RESPONSE TO AN BORD PLEANÁLA OPINION

PROPOSED RESIDENTIAL DEVELOPMENT AT STRADBROOK ROAD, MOUNTASHTON, BLACKROCK, CO. DUBLIN

Figure 2.2: Aerial view of 3D sketch / approximation of Subject Proposal, submitted as part of this SHD Planning Application. (Source: MCA. Cropped by TPA, July 2022.)

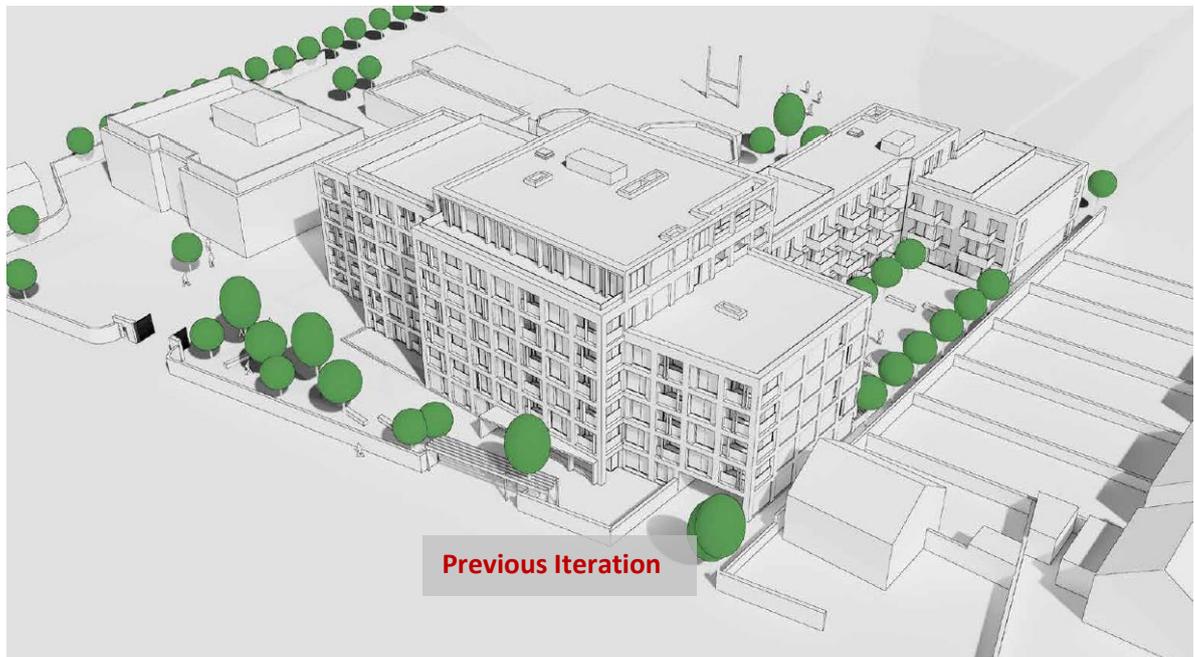
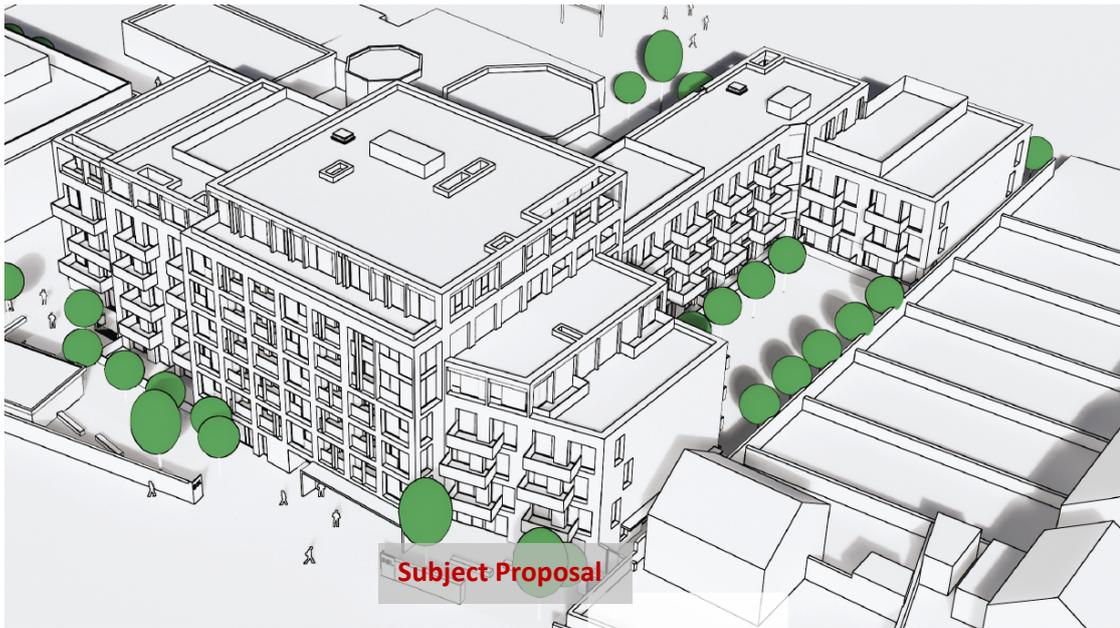
*“Further consideration and/or justification of the documents as they relate to the **overall design, scale and mass**, the **proposed interface with Stradbrook Road**, the **transition with existing dwellings** and the **justification for any material contravention of the height strategy** in the development plan **and compliance with Section 3.2 of the Urban Development and Building Heights: Guidelines for Planning Authorities (2018).**”*

The Subject Proposal has been amended in light of the Board's concerns.

We refer to Figure 2.1 and 2.2, below, which depict the proposed development in its previous and current forms, respectively. Changes to the design are specified below in some detail.
